**Recommended Amendments to the
2024 International Residential Code**
North Central Texas Council of Governments Region

The following sections, paragraphs, and sentences of the *2024 International Residential Code* are hereby amended as follows: Standard type is text from the IRC. Underlined type is text inserted. ~~Lined through type is deleted text from IRC.~~ A double asterisk at the beginning of a section identifies an amendment carried over from the 2021 edition of the code and a triple asterisk identifies a new or revised amendment with the 2024 code.

Fig R327.3

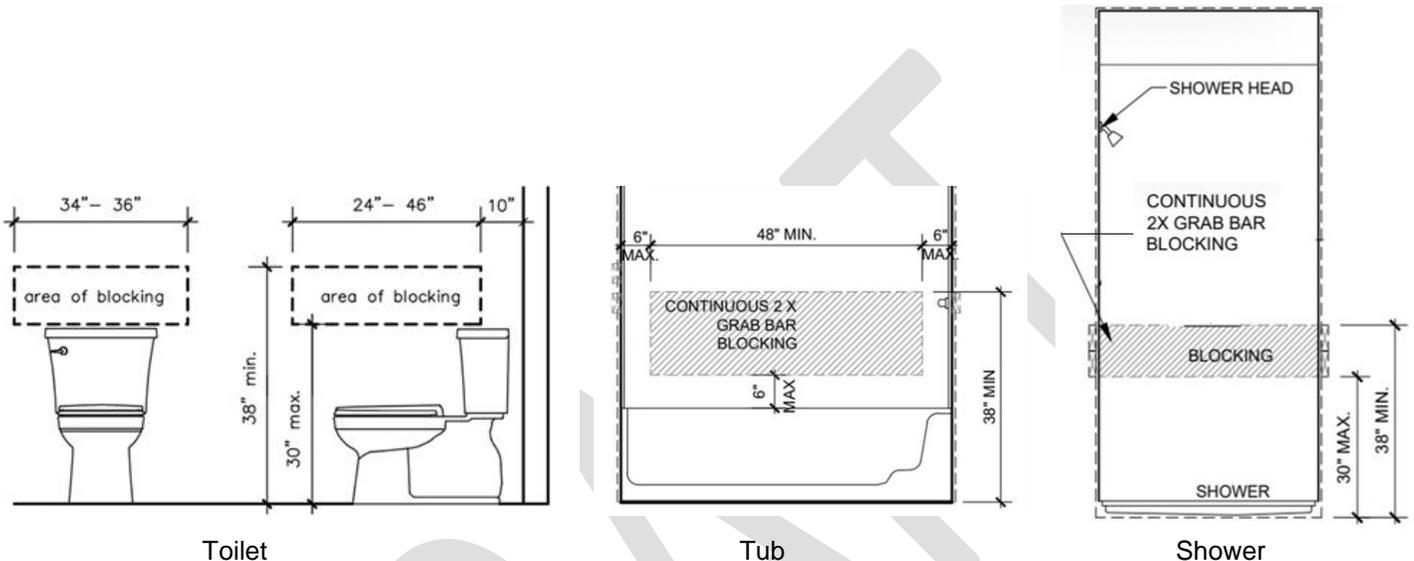
*****R327.3 Blocking Locations; add to read as follows:**

R327.3 Blocking locations. Required at one toilet at grade level with blocking installed at rear wall and, if available, one wall adjacent to toilet and at one tub or shower at grade level. Blocking as shown in Figure R327.3.

Fig R327.4

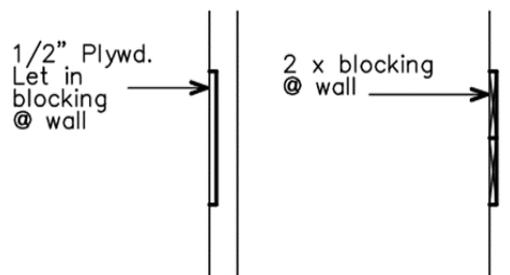
*****R327.4 Wall Blocking; add to read as follows:**

R327.4 Wall Blocking. Blocking may be 1/2" plywood or 2 x solid wood blocking or equivalent, flush with wall as shown in Figure R327.4.

****Figure R602.6.1; delete the figure and insert the following figure:**

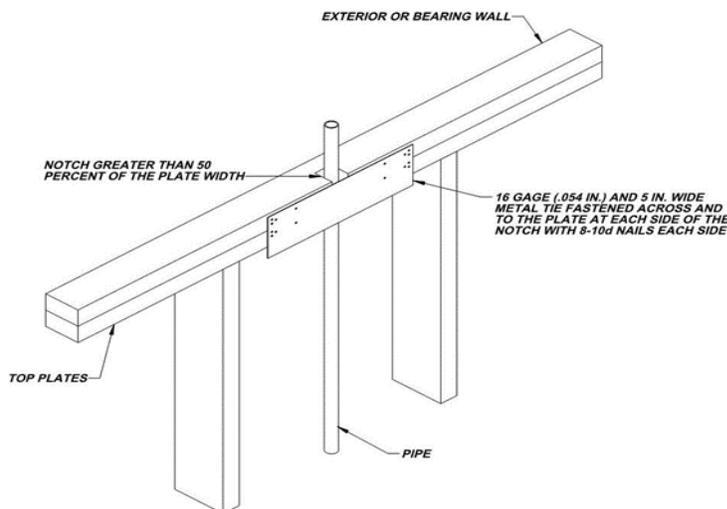
R602.6.1 Drilling and notching of top plate. When piping or ductwork is placed in or partly in an exterior wall or interior load-bearing wall, necessitating cutting, drilling or notching of the top plate by more than 50 percent of its width, a galvanized metal tie not less than 0.054 inch thick (1.37 mm) (16 Ga) and ~~4 1/2 inches (38) mm~~ 5 inches (127 mm) wide shall be fastened across and to the plate at each side of the opening with not less than eight 10d (0.148 inch diameter) having a minimum length of 1 1/2 inches (38 mm) at each side or equivalent. Fasteners will be offset to prevent splitting of the top plate material. The metal tie must extend a minimum of 6 inches past the opening. See figure R602.6.1. {remainder unchanged}

(Amendment to 2021 IRC carried forward to 2024 IRC also provides additional assurance of maintaining the integrity of the framing by spreading the nailing pattern.)
